**City of Portland, Maine – Building or Use Permit Application** 389 Congress Street, 04101, Tel: (207) 874-8703, FAX: 874-8716

Current use: Deck Proposed use: Sun Room  
 Project description: Build 10' X 13' 3 Season Sun Room (Pre Fab Alum)

BUILDING PERMIT REPORT

REASON FOR PERMIT: To Construct a 10x13 3 Season suaroom

EXISTING CONDITIONS

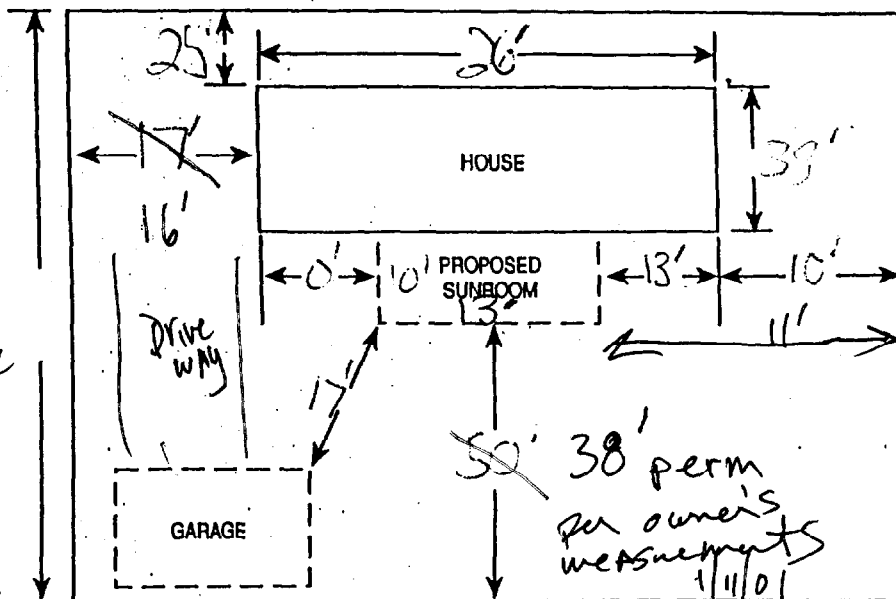
Lot is 50 x 100 - They show 53' x 123'

*R-5 zone*  
 Rear setback: 2d reg - 30' shown  
 Side Setback: 8' reg - 16' & 11' shown

IF PERMITS ARE TO BE PULLED, NEED COMPLETE MEASUREMENTS. The lot Dept. Adds up to 123' The Actual Dept 15' 100'
